ADDENDUM NUMBER ONE

MOCCASIN BEND MAINTENANCE BUILDING RE-ROOFING PROJECT CONTRACT NO. W-17-012-201

CITY OF CHATTANOOGA, TENNESSEE

MBWTP MAINTENANCE
BUILDING RE-ROOF
TEST CORE LOCATION

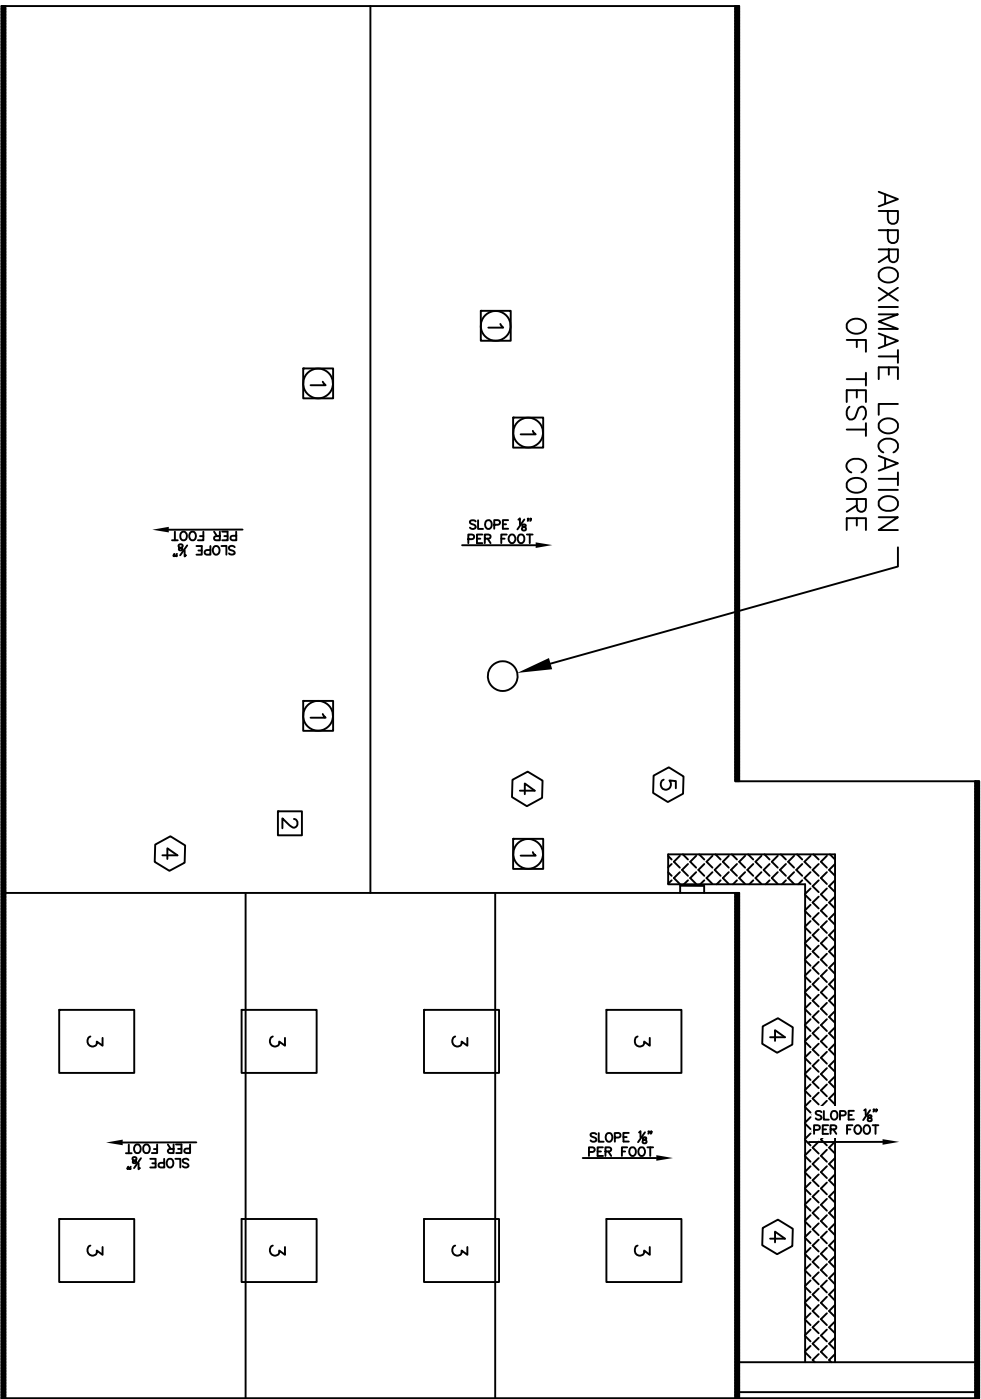
3. One sample of the existing roofing material was taken during the initial roof inspection. The location is indicated on the attached Figure 1. The existing sample was approximately 5-1/2" in thickness, composed of built-up roofing. Much of the existing ballast was removed during a high-wind event in the past, and the remaining ballast has been treated with a spray-on material designed to cause it to adhere together, rather than be loose, to avoid the potential of having it blow off in the future.
